# MINUTES

---

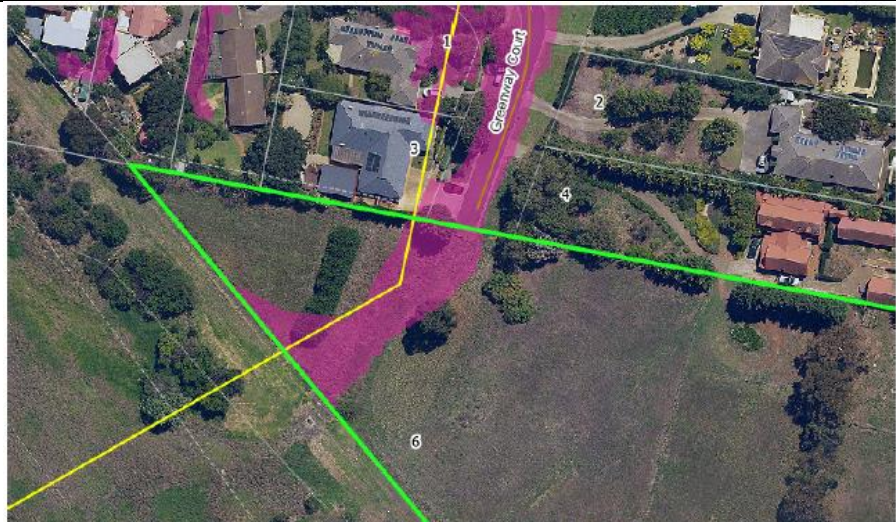
**Officer Comment:**

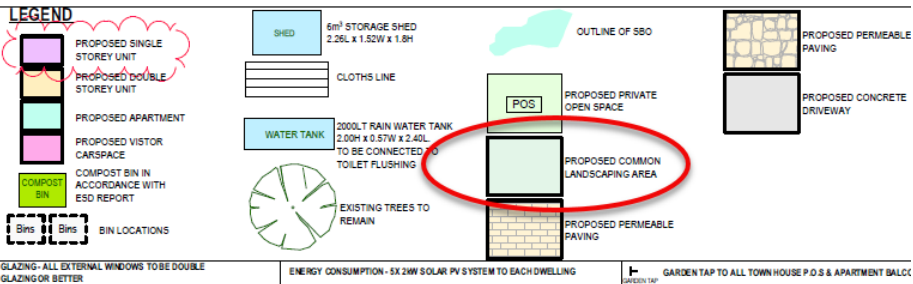
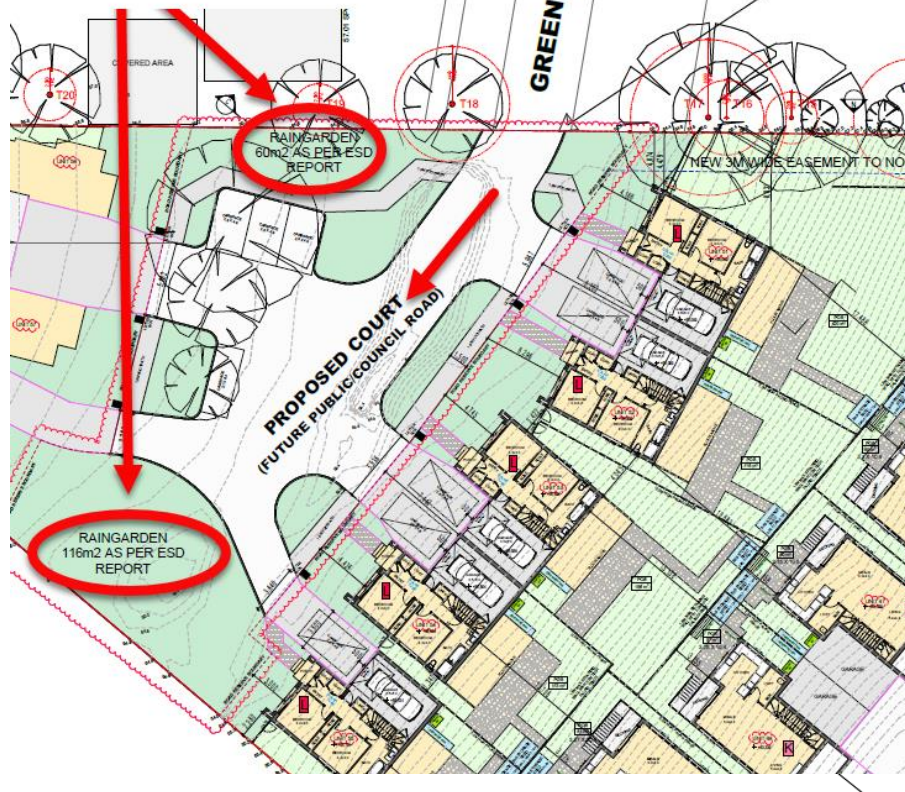
<b>Department:</b>	<b>Environment (ESD Planning)</b>
<b>Response:</b>	<p><b>Supportive</b></p> <p>All works must be undertaken in accordance with the endorsed Plan, ESD report and stormwater management plan to the satisfaction of the Responsible Authority.</p> <p>No alterations to these plans may occur without the written consent of the Responsible Authority.</p>
<b>Officer Comment:</b>	
No objection to the grant of a permit subject to conditions.

<b>Department:</b>	<b>Open Space Planning</b>
<b>Response:</b>	<p><b>Supportive – Subject to access from Basin Rise being resolved.</b></p> <p>Open Space are still of the opinion that the accessway from Basin Rise remains unresolved.</p> <p>Road V's Private Property? I'm unclear if Engineering and/or Barwon Water have a preference for either option?</p> <p>Our concerns remain that if it is to be a private accessway and not a road, how does Council ensure that we maintain right of access (for use and maintenance) for the shared path? Would a carriageway easement be possible? and would this be sufficient for the purpose of access and maintenance requirements?</p> <p>I'm in contact with Barwon Water to try and understand their sale process however am still waiting on a response.</p> <p>If stat planning decide to grant a permit, a condition ensuring the development does not commence until this matter is finalised will be important.</p> <p><b>Recommended Permit Conditions (Without Prejudice)</b></p> <p><b>Commencement of Works</b></p> <p>Prior to the commencement of any works... (insert resolution of access arrangement from Basin Rise).</p> <p><b>Amended plans</b></p> <p>Prior to the commencement of works, amended plans to the satisfaction of the Responsible Authority must be submitted to and approved by the Responsible Authority. When approved, the plans will be endorsed and will then form part of the permit. The plans must be drawn to scale with dimensions and must be generally in accordance with the plans submitted with the application but modified to show:</p> <ol style="list-style-type: none"> <li>a) Fencing detail that allow a minimum of 30% permeability.</li> <li>b) Design of accessway over the shared path. The design must include traffic calming measures and/or signage with priority given to shared path users.</li> </ol>

<p><b>Access and Storage Prohibited on Council Reserves</b></p> <p>There must be no parking, access through or storage on the adjoining Barwon Water reserve at any time during construction.</p>
<p><b>Officer Comment:</b></p> <p>No objection to the grant of a permit, subject to conditions. Generally, these conditions should be included on any permit that were to be issued.</p> <p>It is recommended that any permit include a condition requiring the owner of the land enter into a Section 173 agreement to formalise the access arrangements to Basin Rise in a manner that burdens the subject site landowner to create a carriageway easement, and to construct and maintain an accessway to their property in accordance with the design and maintenance requirements of both the City and Barwon Water.</p>
